*Southern California Edison*  
**Moorpark-Newbury A.13-10-021**

**DATA REQUEST SET A1310021 Moorpark-Newbury-ED-SCE-03**

**Question Q.07:**

**Question Q.08:**

**MOORPARK-NEWBURY 66 KV  
SUBTRANSMISSION LINE PROJECT  
CONCEPTUAL CAMGEN RECONNECTION ROUTE**

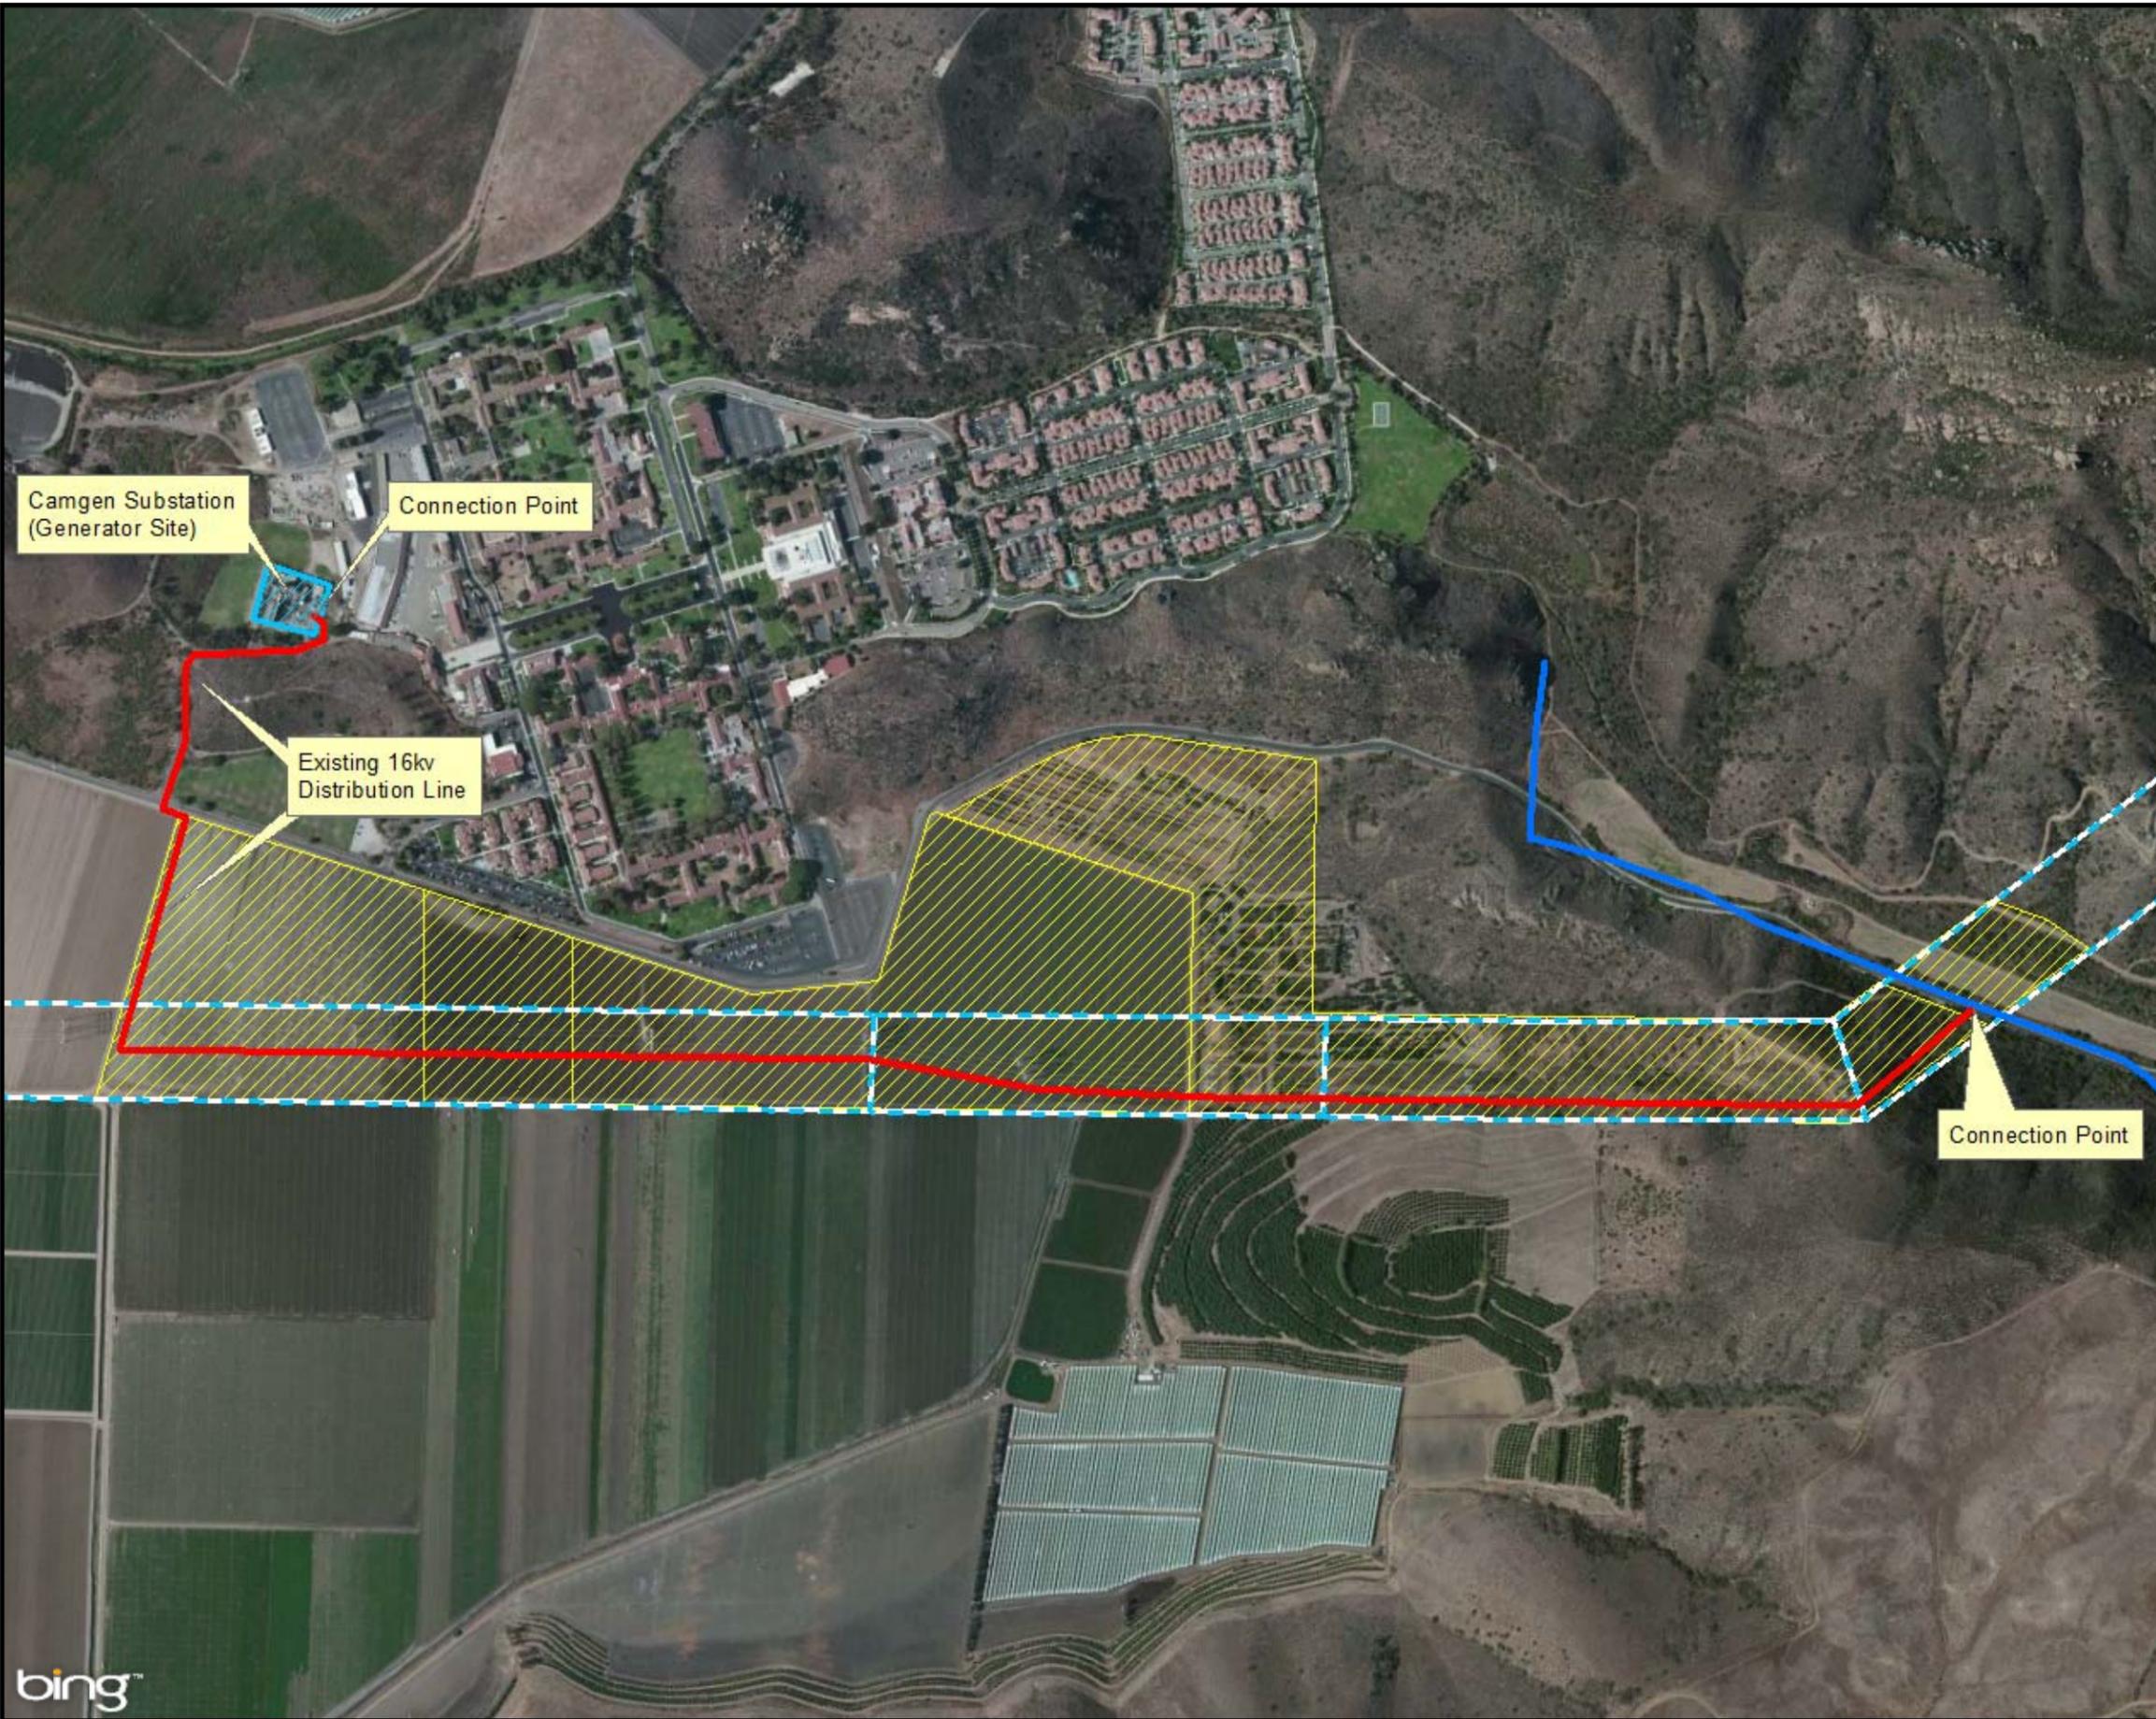
Provide a system single-line diagram indicating how the CAMGEN unit may be interconnected into the Moorpark system. Identify ROW that is available for this connection and where it is not or may not be available. A map or maps of the area clearly identifying the generator site, potential interconnection points, and known ROW restrictions would be helpful. Describe all known issues and currently known potential problems with achieving this interconnection. Provide details as to each of the issues/problems stated. It is understood that the generator is presently connected to the Santa Clara system; describe any impacts (including the severity of each) that would occur to the Santa Clara system if the power generated by the CAMGEN unit were to be transferred to the Moorpark system.

(b) There is an existing 16 kV distribution line coming out of Camgen that would need to be overbuilt and SCE would need to acquire a transmission easement from the east side of Camgen that would follow the existing distribution line, extending south for approximately 0.29 miles until the route reaches a SCE fee owned parcel where the line would continue.

(c) Please see attached map identifying the location of the generator and a conceptual Camgen reconnection route. The existing distribution easement is for distribution purposes only; therefore, a new 25-foot transmission easement would need to be acquired from the University. The potential connection point would begin at a pole outside of Camgen Substation. The conceptual route would follow the distribution line south to Potrero Road. The line would continue heading south, crossing Potrero Road, until it reaches the Moorpark-Ormond Beach ROW. From there it would parallel the Moorpark-Ormond Beach 220 kV Transmission Line to the east. The conceptual route would potentially connect into the existing idle section of the Newbury-Thousand Oaks 66 kV Subtransmission Line.

Conceptual 3-Circuit 66 KV Structure (Not to Scale)  
 Dimensions for illustrative purposes only and could vary based on field conditions

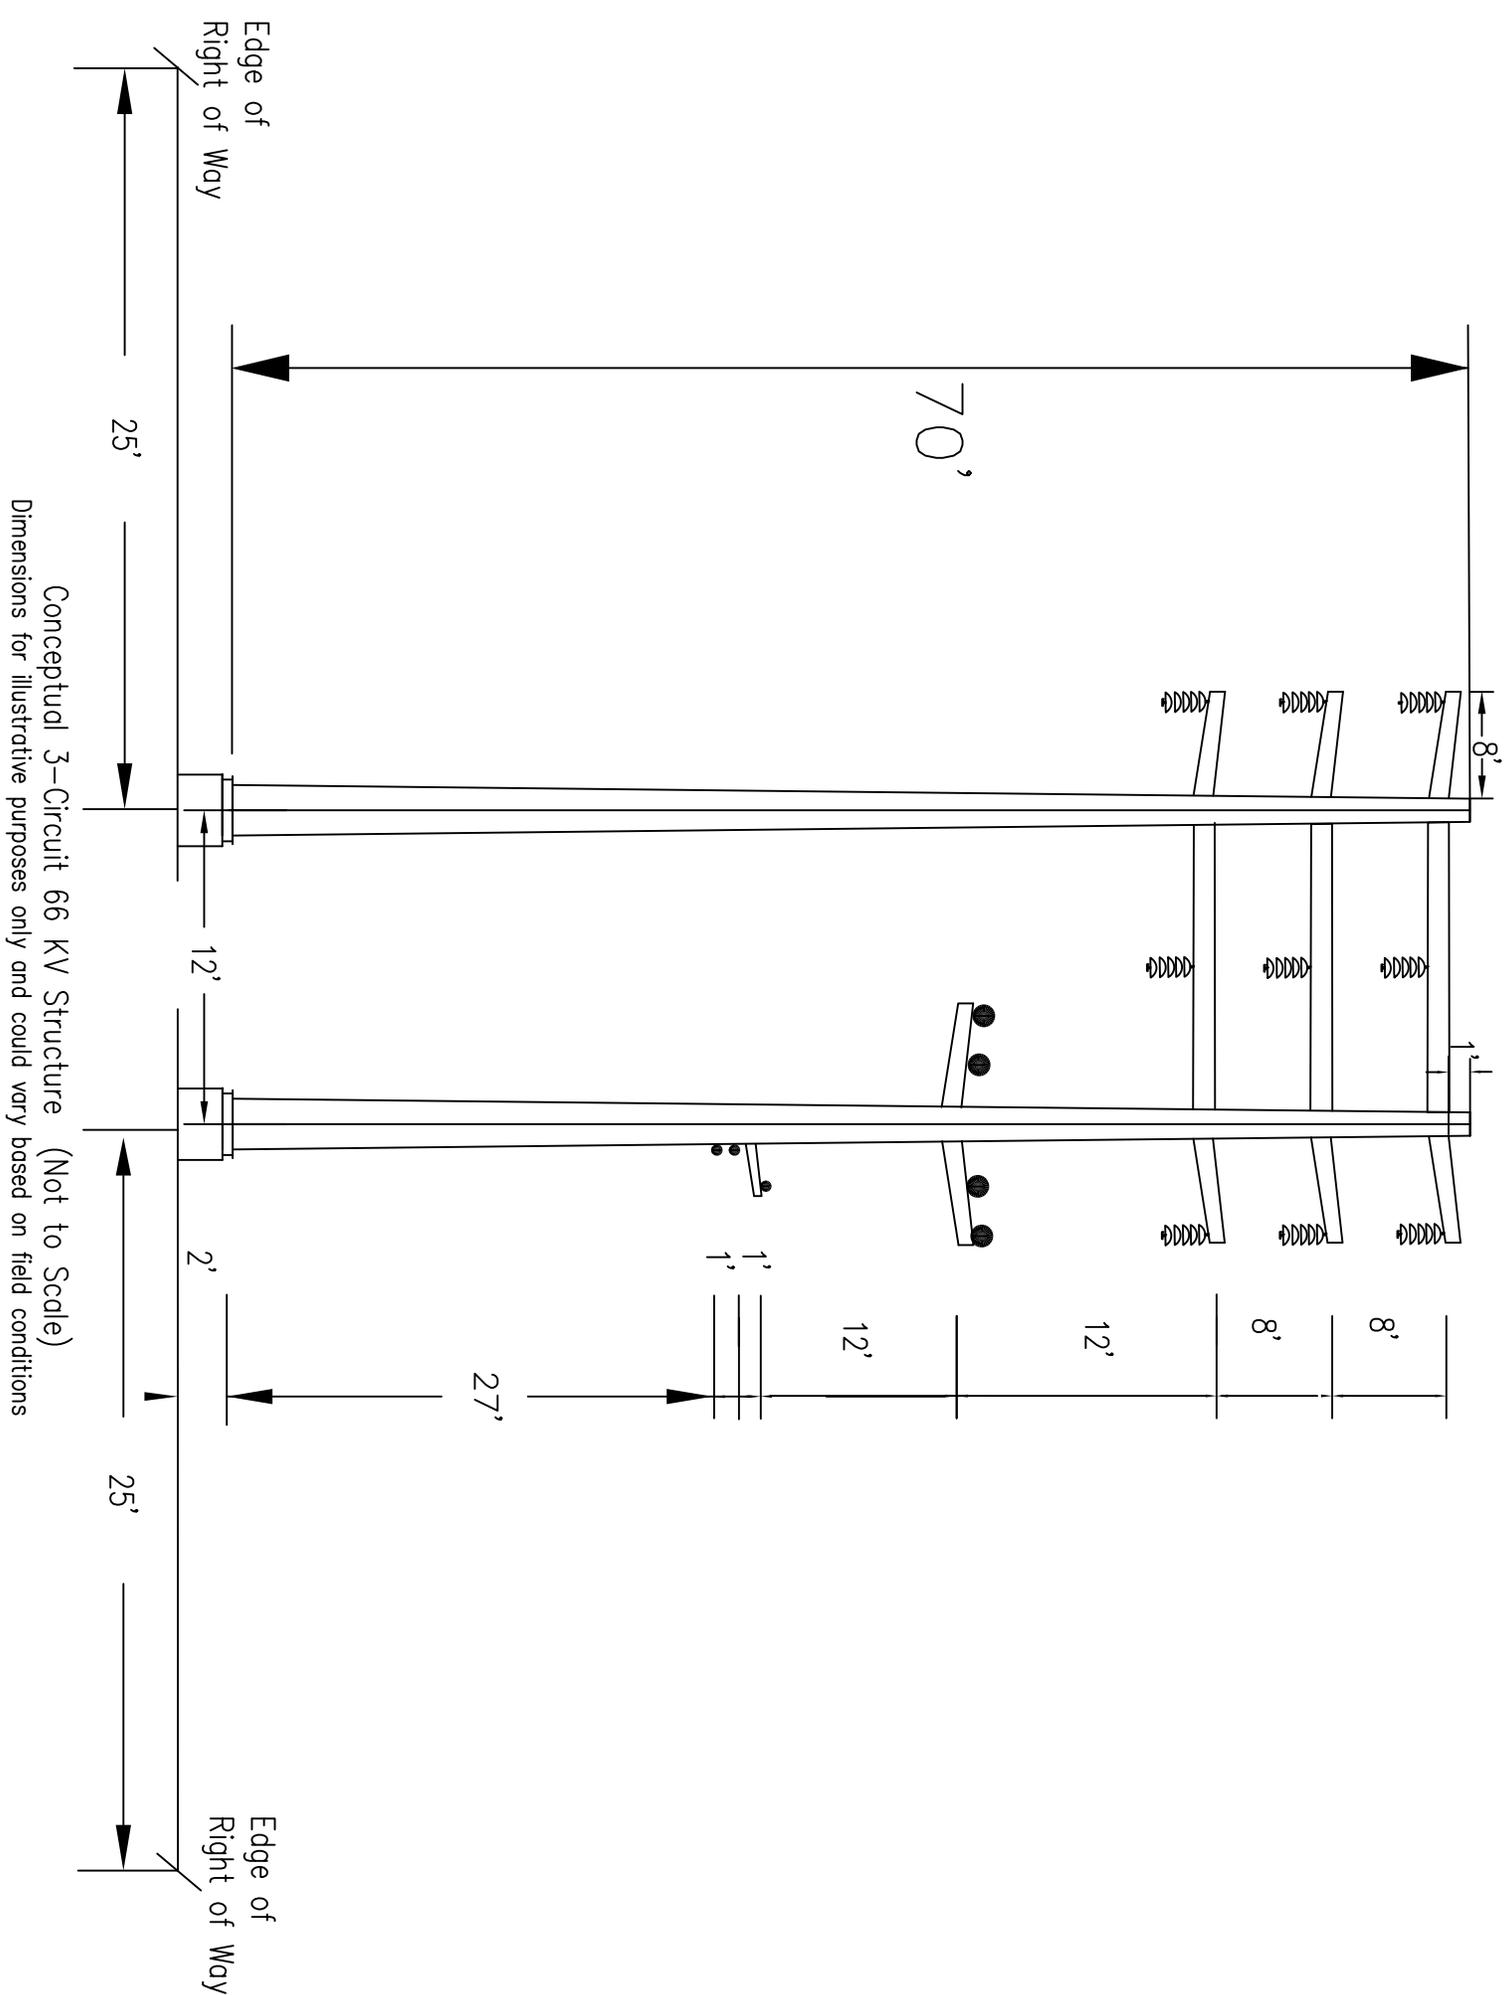
- c. For Subtransmission Line Route Alternative 3, provide detail on why the existing double circuit subtransmission lines cannot be collocated on new lightweight steel or tubular steel poles with the proposed new subtransmission line on the north side of State Route 118 within SCE's existing ROW. Please provide a drawing with dimensions of the associated triple-circuit poles that would be required. Please also address the potential of including an additional new subtransmission pole line immediately north of the existing double circuit pole line on the north side of State Route 118, including the possibility of locating the new poles within the existing subtransmission line ROW.

c. If SCE had to install three subtransmission circuits on new lightweight steel or tubular steel poles, SCE would build a unique structure that accommodates three circuits in vertical configuration, as shown in the attached figure. However, the footprint of such a structure would be significantly larger than the footprint of the existing double-circuit poles. It should be noted that SCE does not have an exclusive ROW on the north side of Highway 118; the existing poles are located within the existing Caltrans ROW. For such a structure, SCE would require an approximate 65-foot wide ROW for the new structures compared to the current poles, which are generally within an approximately 20-foot footprint. A simple review of a Google Earth map shows that there is insufficient room between the nearby Union Pacific Railway ROW and Highway 118 to accommodate such structures.
